A DESCRIPTION AND VALIDATION  
OF STEADY-STATE ANALYSIS  
METHODS FOR BOILING WATER REACTORS  
AMENDMENT 1

RESPONSE TO NRC QUESTIONS

DECEMBER 1983

This amendment to Topical Report NF-1583.01, "A Description and Validation of Steady-State Analysis Methods for Boiling Water Reactors," is provided in response to requests for additional information as conveyed by Enclosure 3 of the letter to Mr. E. E. Utley, CP&L, from Mr. Domenic B. Vassallo, NRC Division of Licensing, dated November 1, 1983.

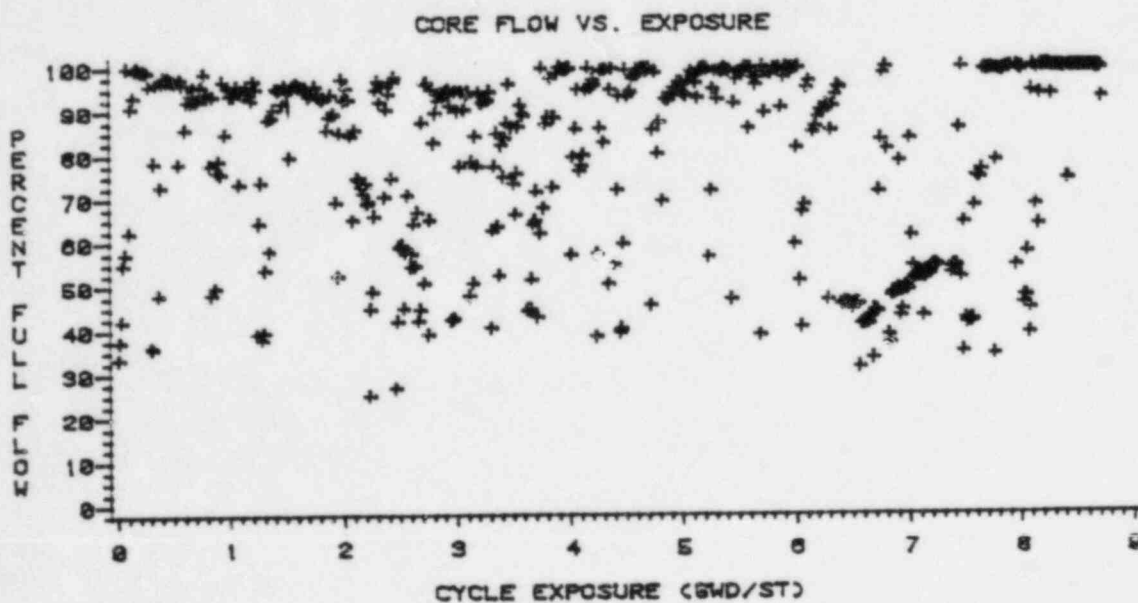
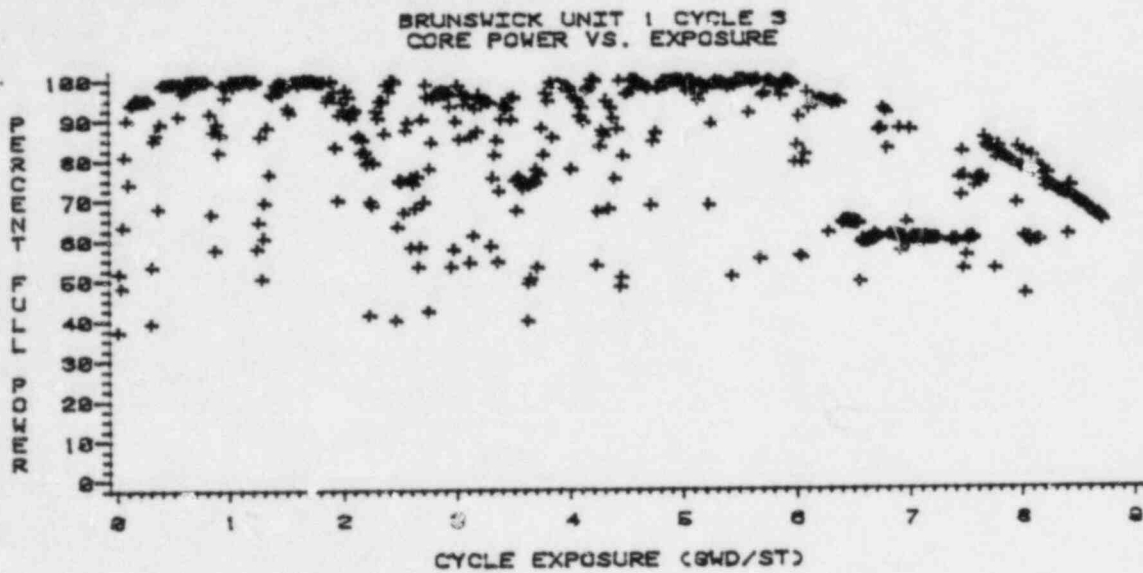
QUESTION 10 (NF-1583.01)

(Section 5.1)

Please provide power and flow histograms for a typical cycle that was used in the verification data base.

RESPONSE

Figure 11.1

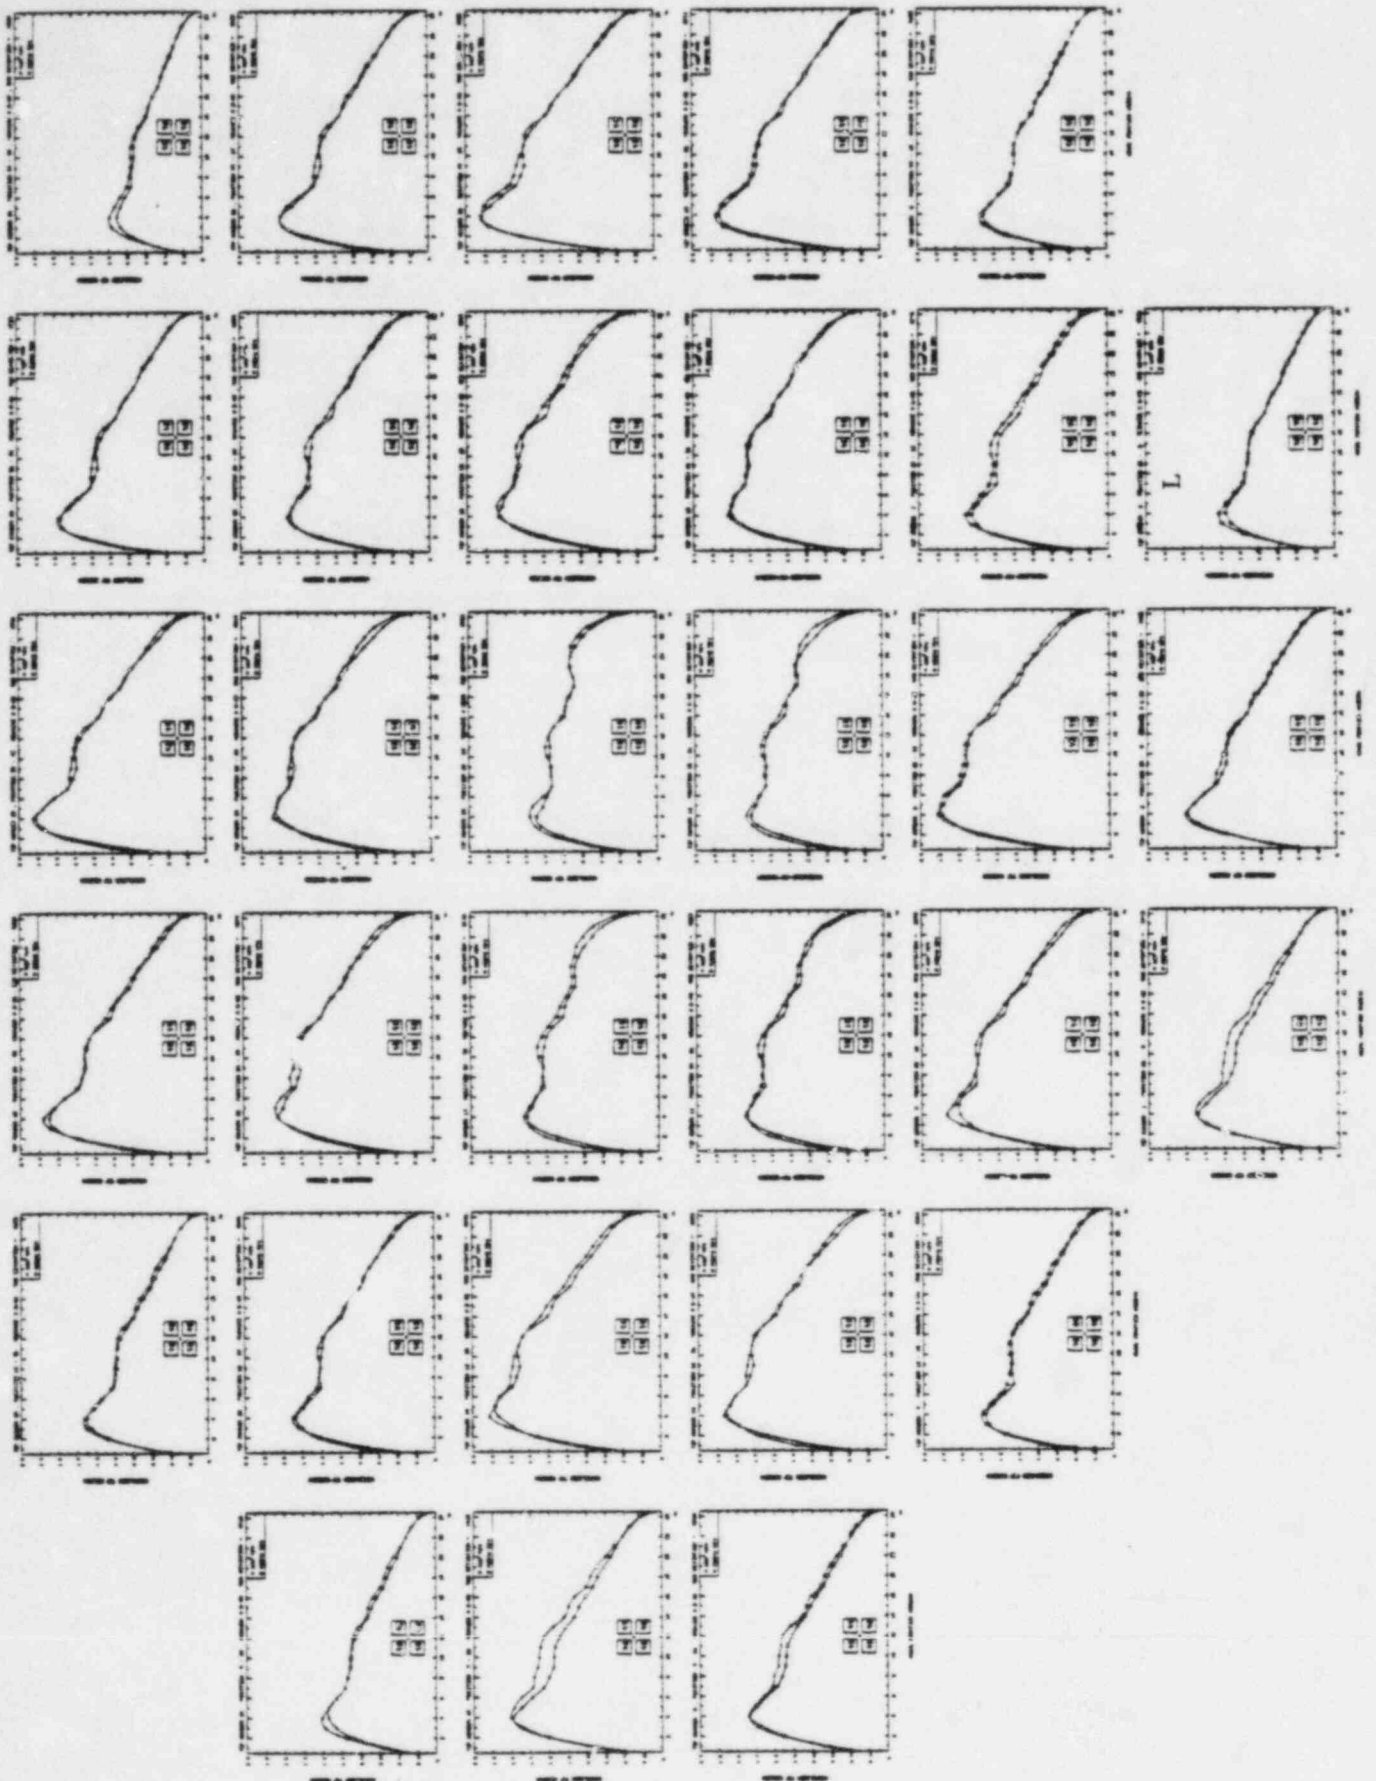
Please provide data showing PRESTO-TIP comparisons for individuals TIPS. Data similar to that shown in the March 11, 1982 meeting will suffice if legibility can be improved. Alternately, choose several individual traces representing different control rod insertions and time in cycle.

Included are multiple TIP plots for each Brunswick cycle presented in NF-1583.01, each showing thirty-one individual TIP traces. Figures 11.1 through 11.9 show different control rod insertions for each cycle, as indicated in Table 5.5.1 of NF-1583.01. Four sets of full-size copies are enclosed for detailed inspection.
